IN RE: PUERTO RICO ELECTRIC POWER
AUTHORITY RATE REVIEW

CASE NO.: NEPR-AP-2023-0003

**SURREBUTTAL TESTIMONY IN RESPONSE TO
THE “EXPERT REPORT OF JUSTO GONZÁLEZ, PE”**

PC Exhibit 64.0 On the Matter of Generation

2025 Unit Repairs and Restorations

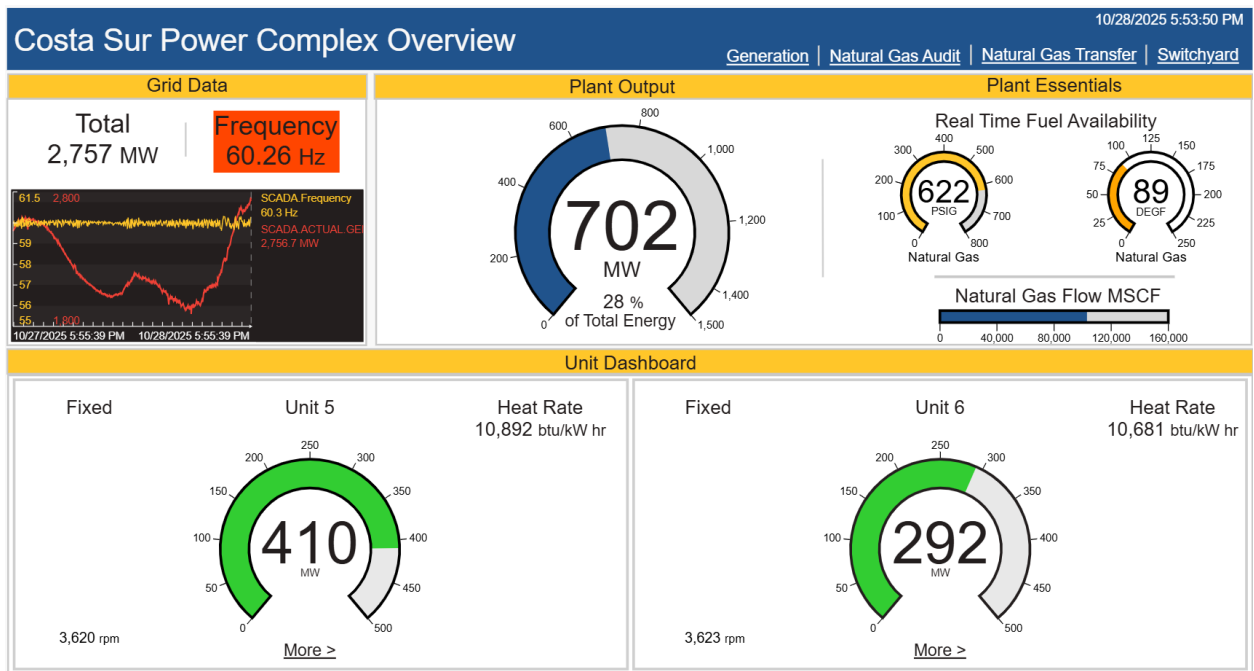
B.1 Current System Conditions and September 29, 2025 Snapshot. The report presents a single-day capacity shortfall projection and generalizes it. See table below, which summarized the major unit repairs and return-to-service milestones completed during 2025. These restorations materially improved system adequacy and were not reflected in the Expert Report’s snapshot analysis.

Genera agrees that additional funding is needed; however, the statements presented in the report do not reflect Genera's actual performance in bringing units back online. The snapshot fails to incorporate the 2025 restorations, nor does it account for DOE and CDBG-DR funding obligations that change the rate-recovery profile for FY26.

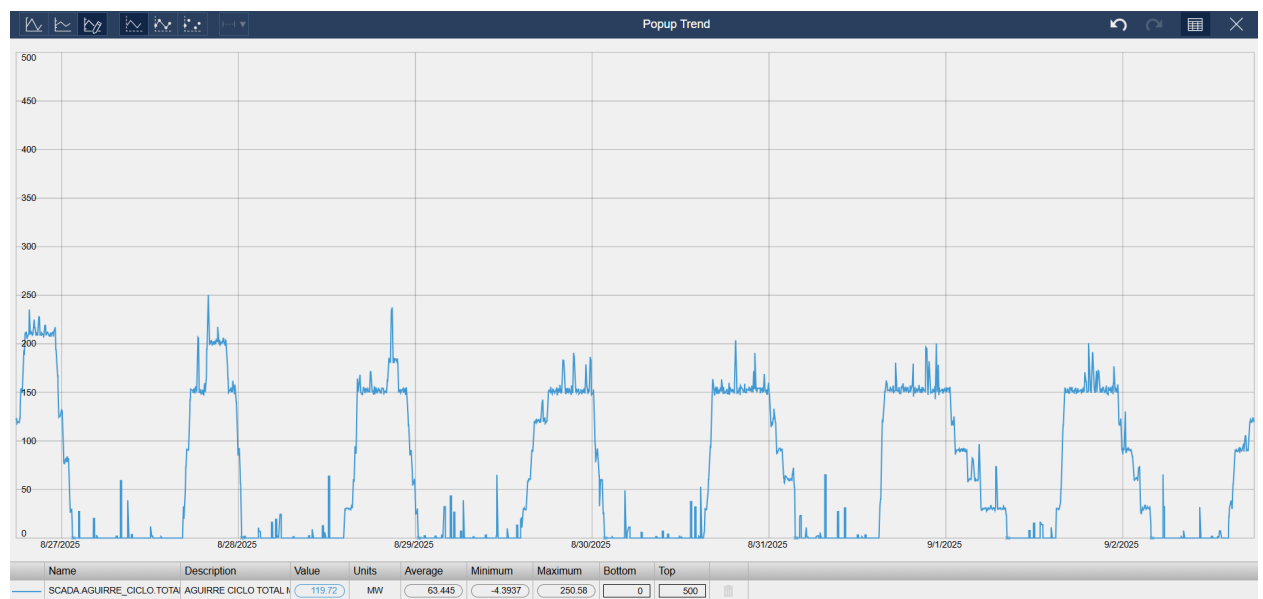
11 Regarding the program lists (Table VII), Genera confirms that the Aguirre economizer
12 replacement is already funded by DOE and will not be borne by ratepayers, and that other
13 line items are being evaluated for FEMA Critical Parts Replacement Program eligibility—
14 consistent with the report's suggestion to utilize federal funding first.

Aguirre Combined Cycle – Historic Data by Week

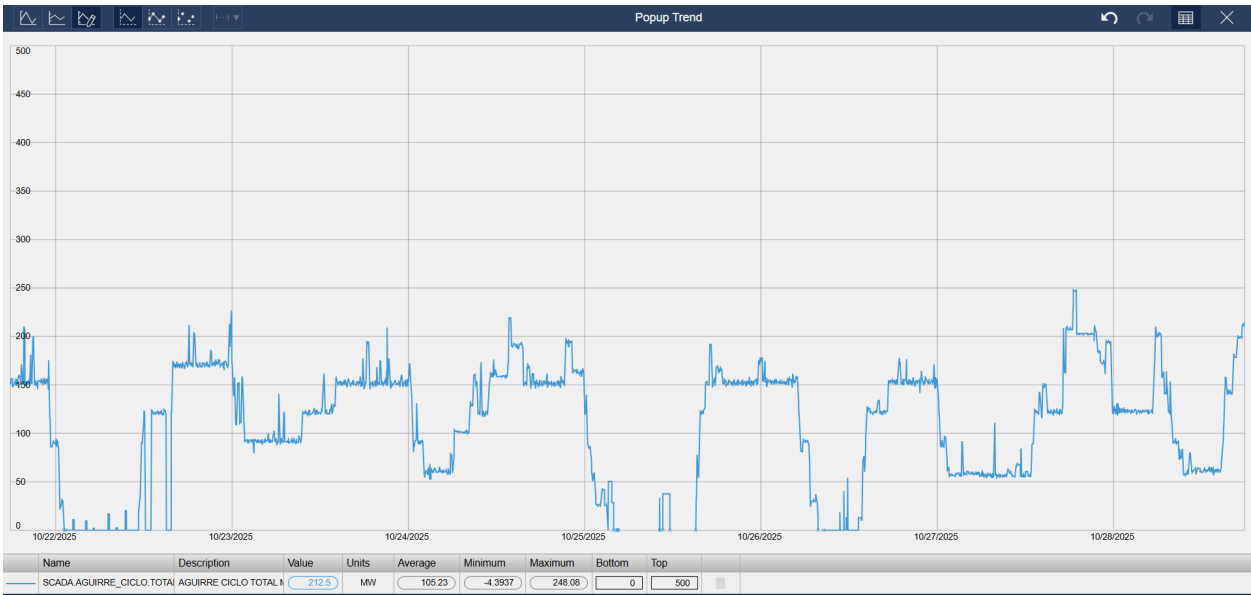
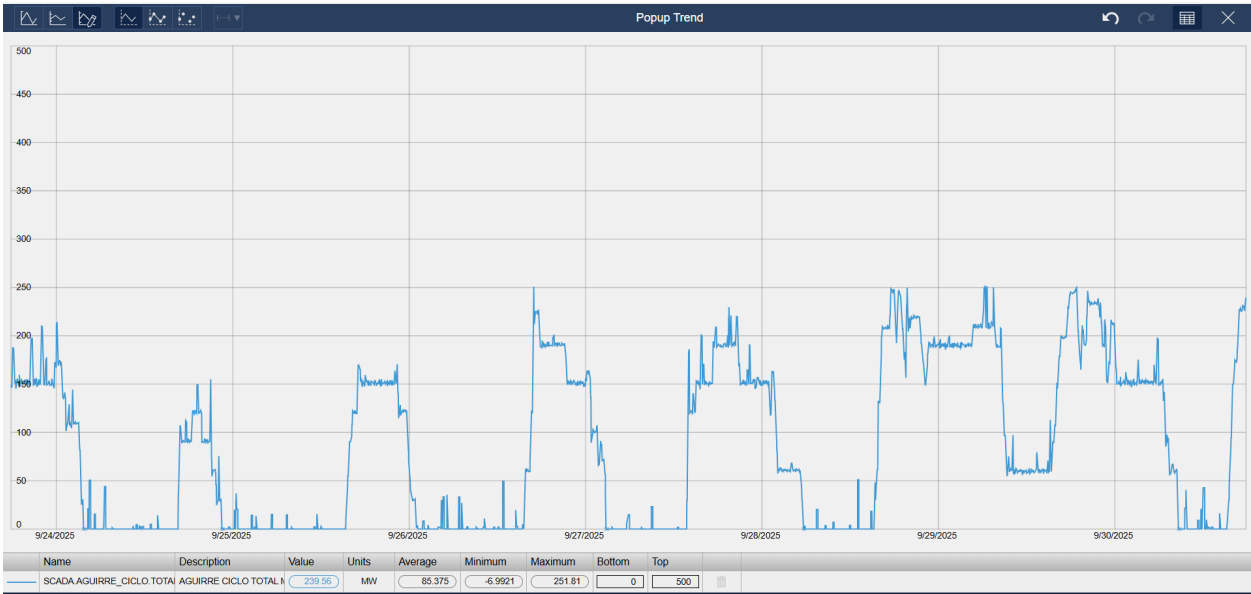
C.5 Aguirre Combined Cycle Programs that may be Suitable for Consolidation. The report's recommendation to "consolidate" the Aguirre Combined Cycle into a single STAG unit is unsupported by current generation needs and, if implemented without alternative generation available, could further compromise system reliability and reserves. Since January 2025, both STAG units have been generating and contributing to system adequacy; without these units, the system would have faced insufficient generation. There is also a contradiction with the report, while Eng. González criticizes Genera's reuse of components from non-operational units as a source of spare parts at the San Juan Power Plant, he simultaneously urges part transfers between the two STAG units.
